RE: NORTH AUSTRAL WOOLWORTHS

1. As requested, we have reviewed the traffic matters raised in Council's RFI letter dated 1 October and TfNSW's letter dated 20 September, for the above development. A subsequent meeting with Council was held on 16 October to discuss these matters. The traffic matters raised, and our responses are set out below.

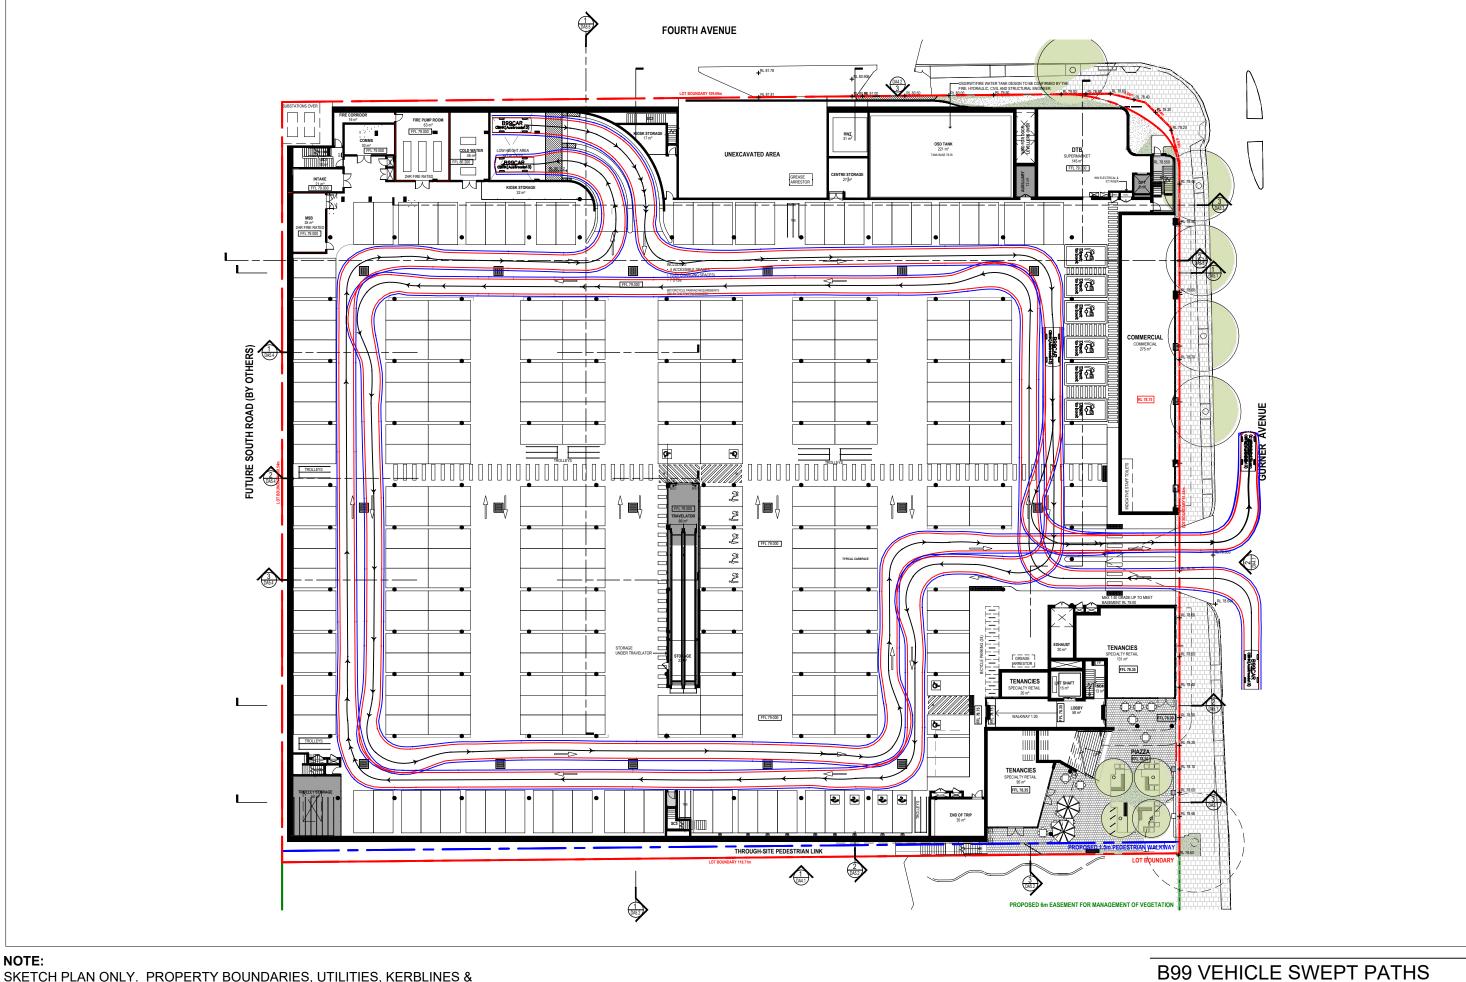
- 10. TfNSW raised a matter in relation to access from Gurner Avenue. This matter and our response is set out below.
 - TfNSW have identified that the proposed ingress and egress driveway in Gurner Avenue (**local road**) for this development is located between the two existing driveways servicing AI-Faisal College and within the extents of the existing school zone. To improve road safety and traffic flow during peak school periods it is recommended that the proposed access be restricted to left- in, left-out (**LILO**) movements only.

- 11. Access to the site via Gurner Avenue is left turns in/out and right turn in with no right turn out. As noted previously, SIDRA modelling of this access found the Gurner Avenue access will operate at a good level of service with minimal delays and queues during the peak periods (this included the existing school accesses).

- 12. Furthermore, as part of the redevelopment of the adjacent school, the existing accesses to/from Gurner Avenue will be relocated to Fourth Avenue, thus removing the concern raised by TfNSW.

- 13. Based on the above access, no changes are required to the Gurner Avenue access (that is, access to remain left turns in/out and right turn in with no right turn out). As noted in Paragraph 2, provision of the right turn into the site will provide for good customer access and better disperse traffic on the adjacent road network.

VEHICLE SWEPT PATHS

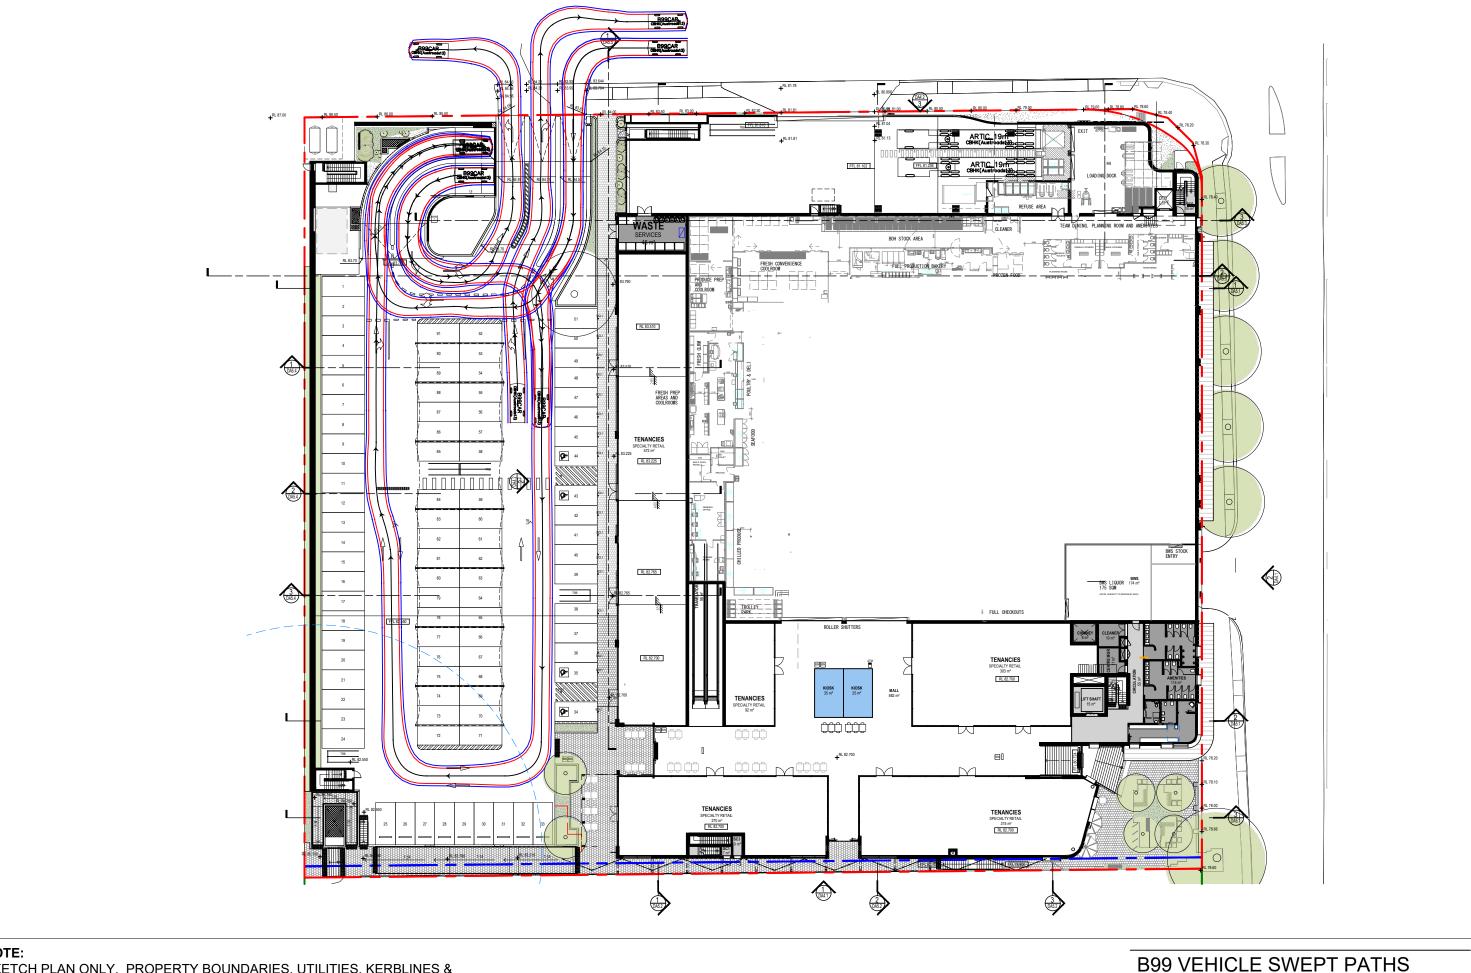
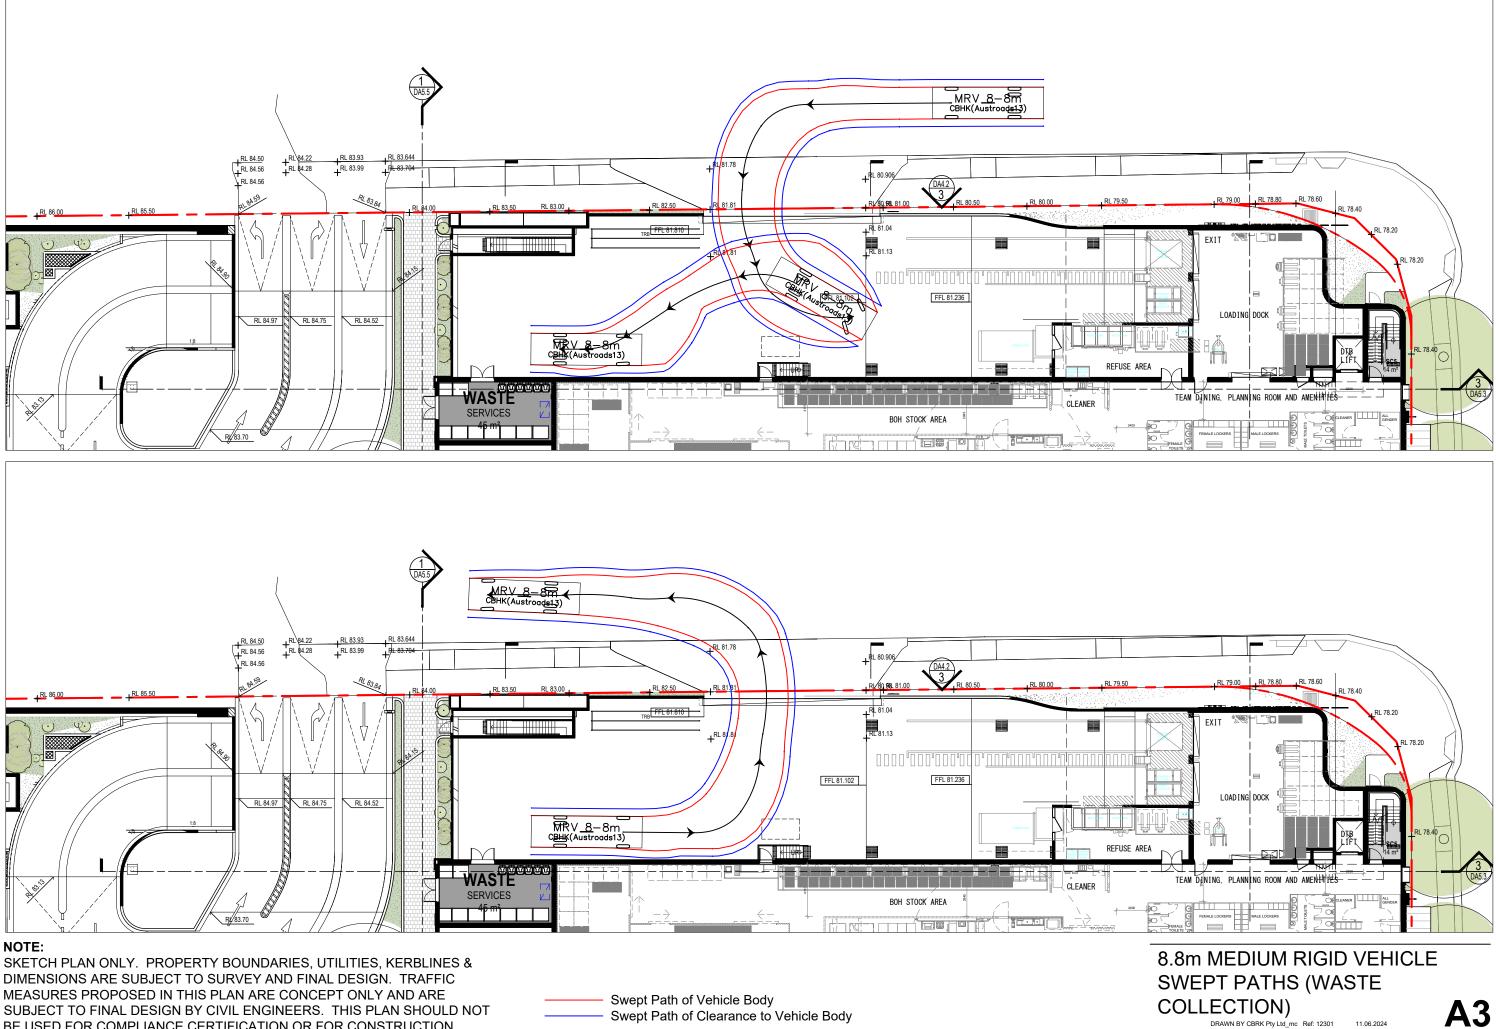
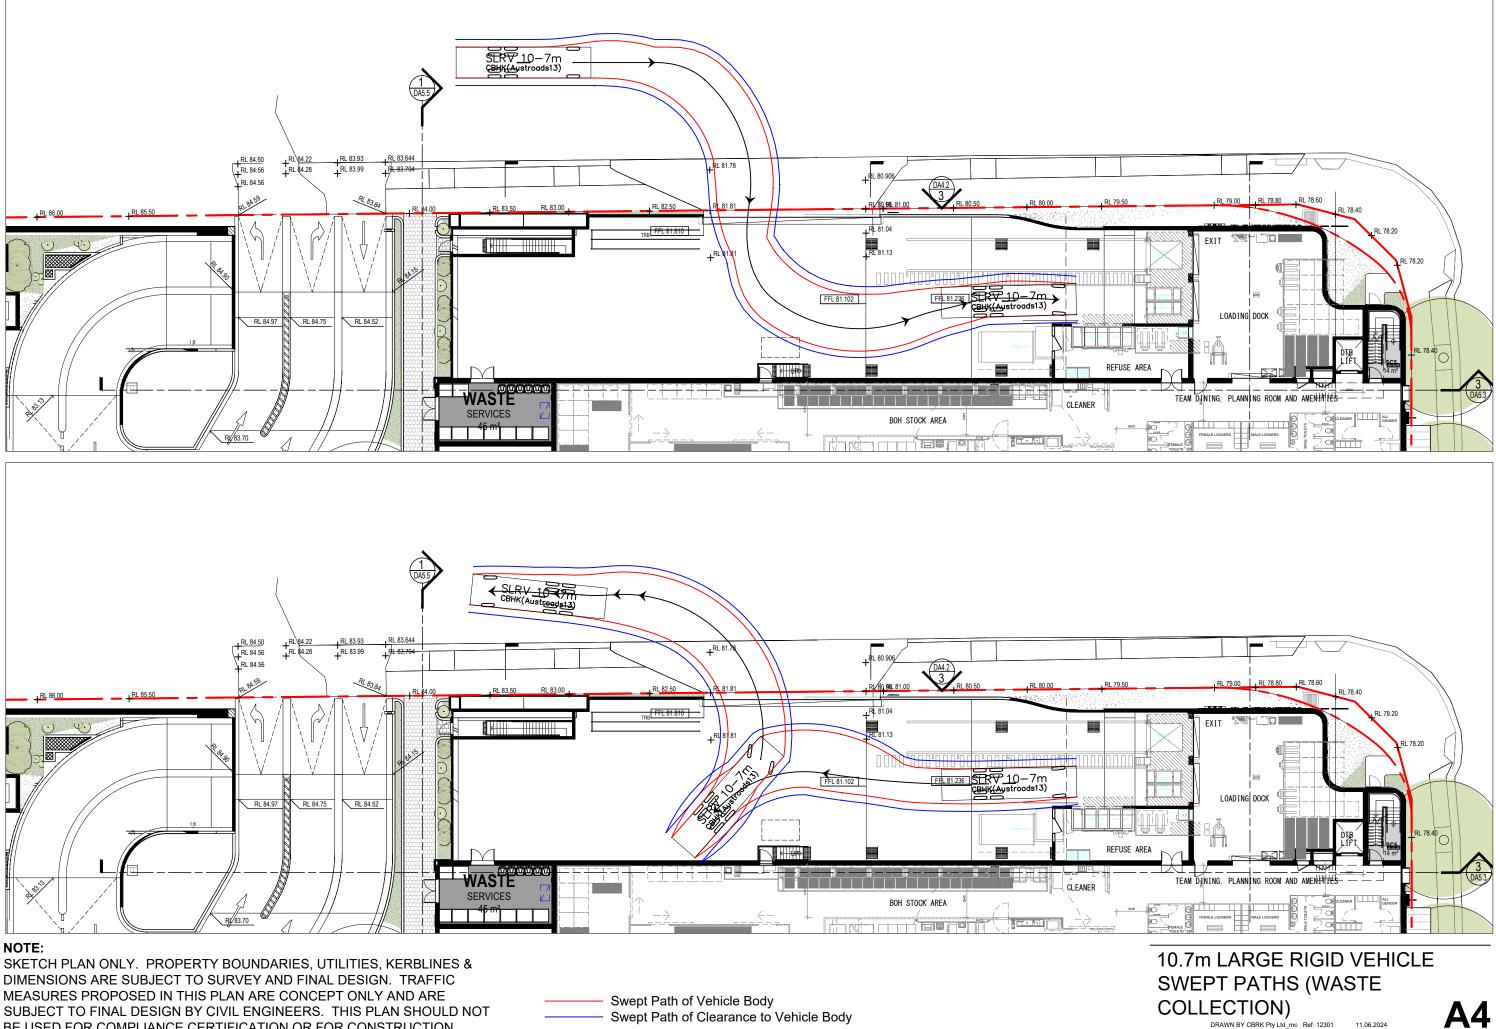
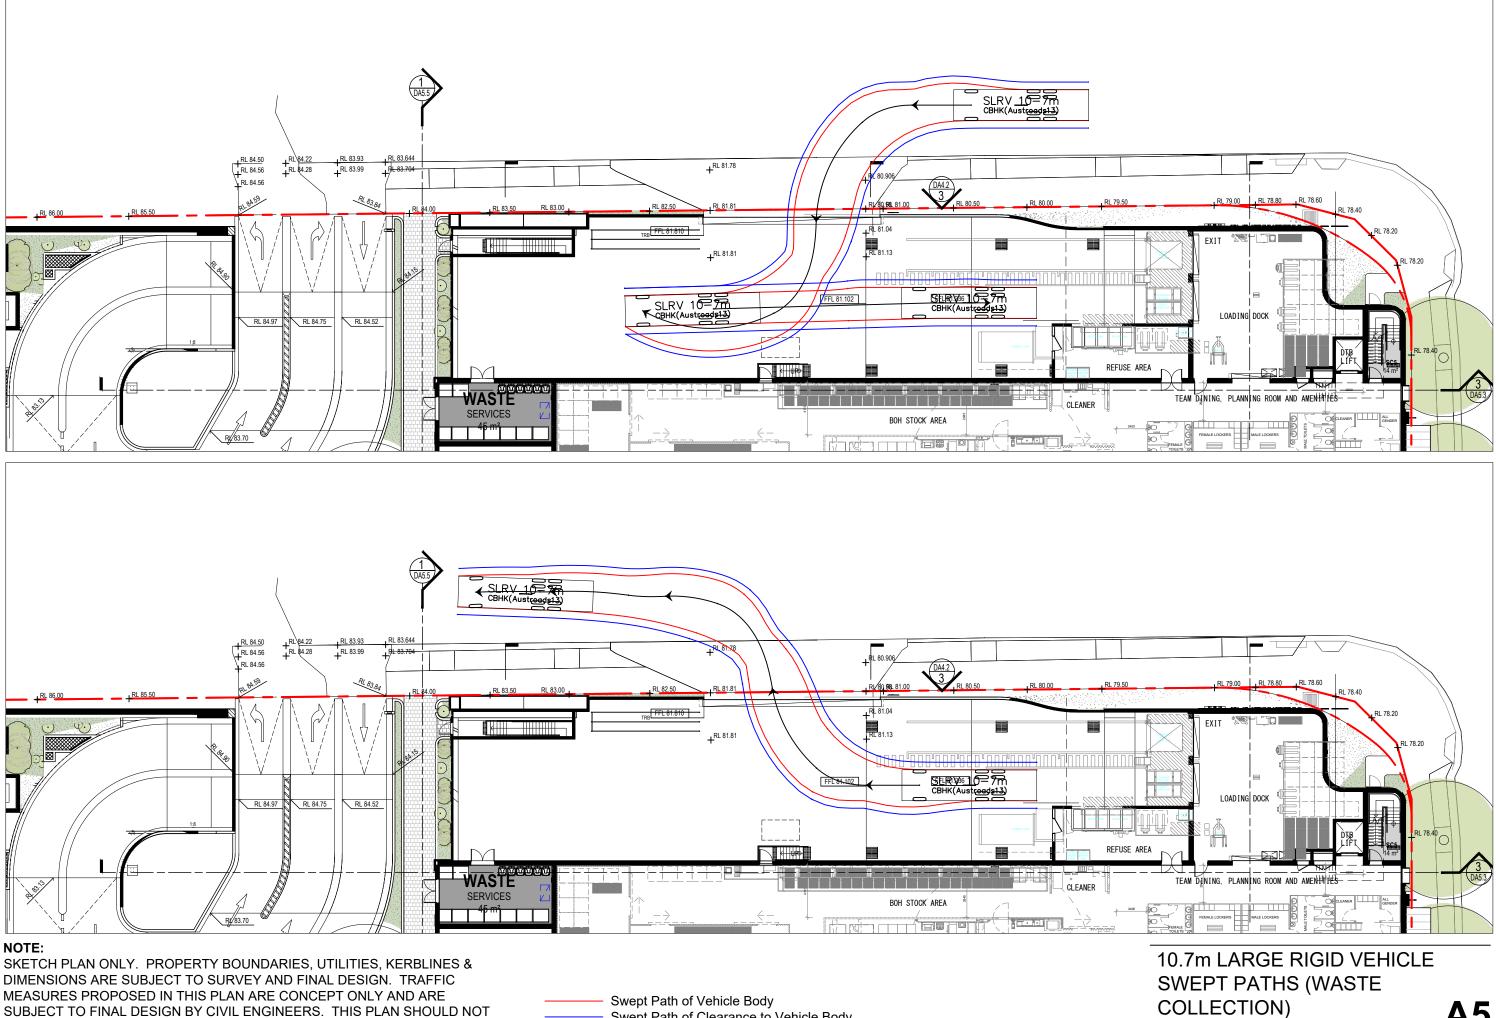
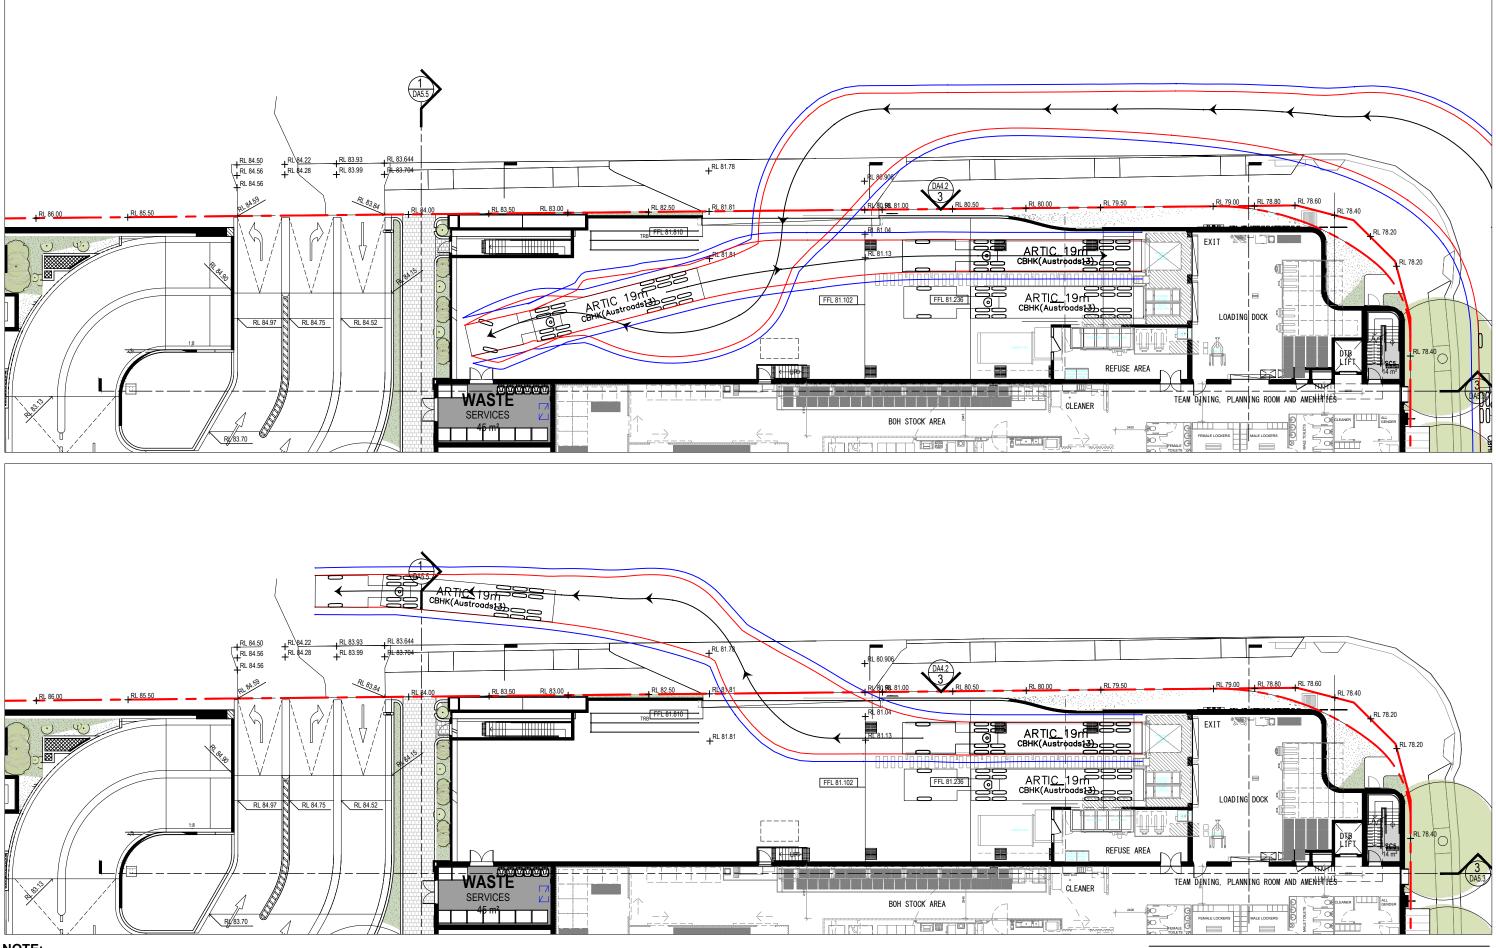
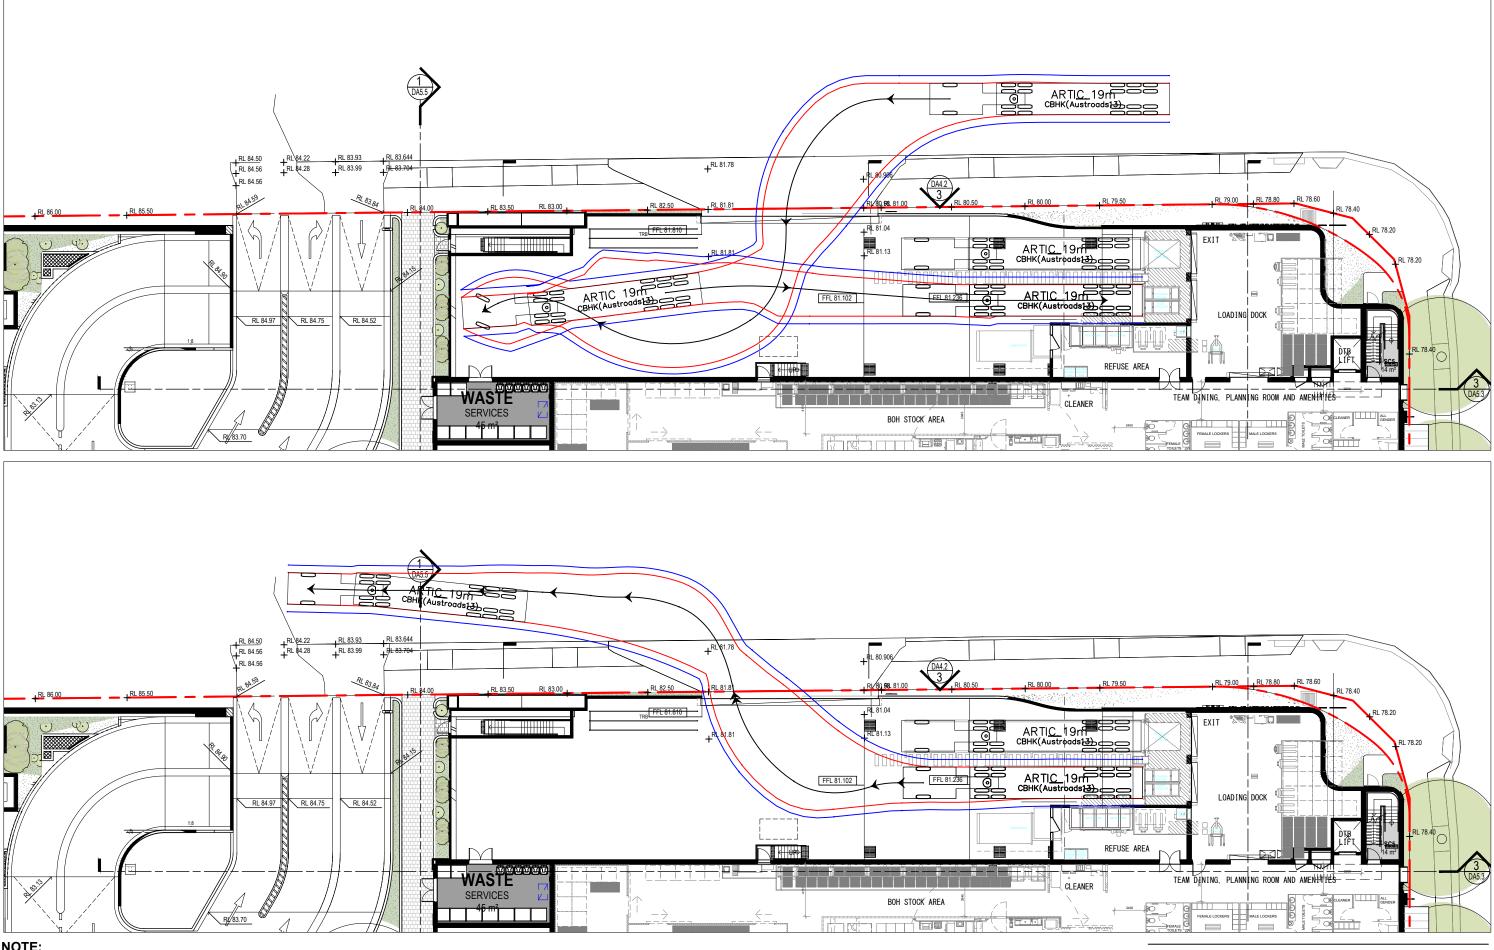
- 20) Access arrangements, parking layout, servicing and vehicle swept paths should be reviewed and confirmed with compliance certification.

- 8. Access arrangements, parking layouts and servicing arrangements have been reviewed and generally comply with Australian Standards AS2890.1:2004, AS2890.2:2018 and AS2890.6:2022. Vehicle swept paths were provided in the traffic report in association with the DA for this development and are provided as Attachment A in this letter.
- 9. Following DA approval, access arrangements, parking layouts, servicing and vehicle swept paths should be reviewed and confirmed for compliance certification
